**SECTION 00 91 02
ADDENDUM NUMBER 2**

PROJECT: OEHS/OHS BOILERS AND CHILLERS
1525 HARVEY ROAD, 4250 ROUTE 71
OSWEGO, ILLINOIS 60543

PROJECT NO: 21-158-1389

M310

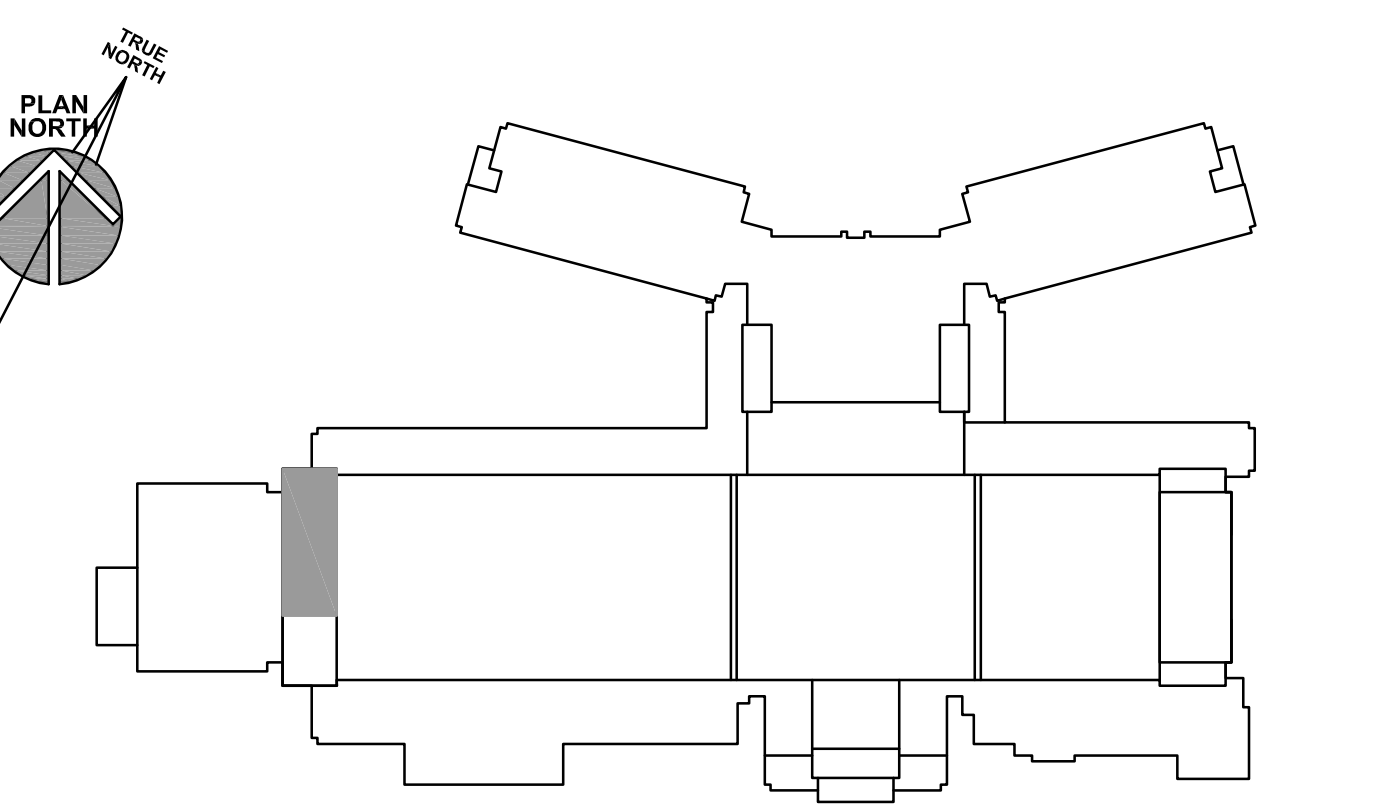
3.01 DRAWING M310 - OEHS MECHANICAL FOURTH FLOOR PLANS

- A. Replace sheet M310 with the attached.
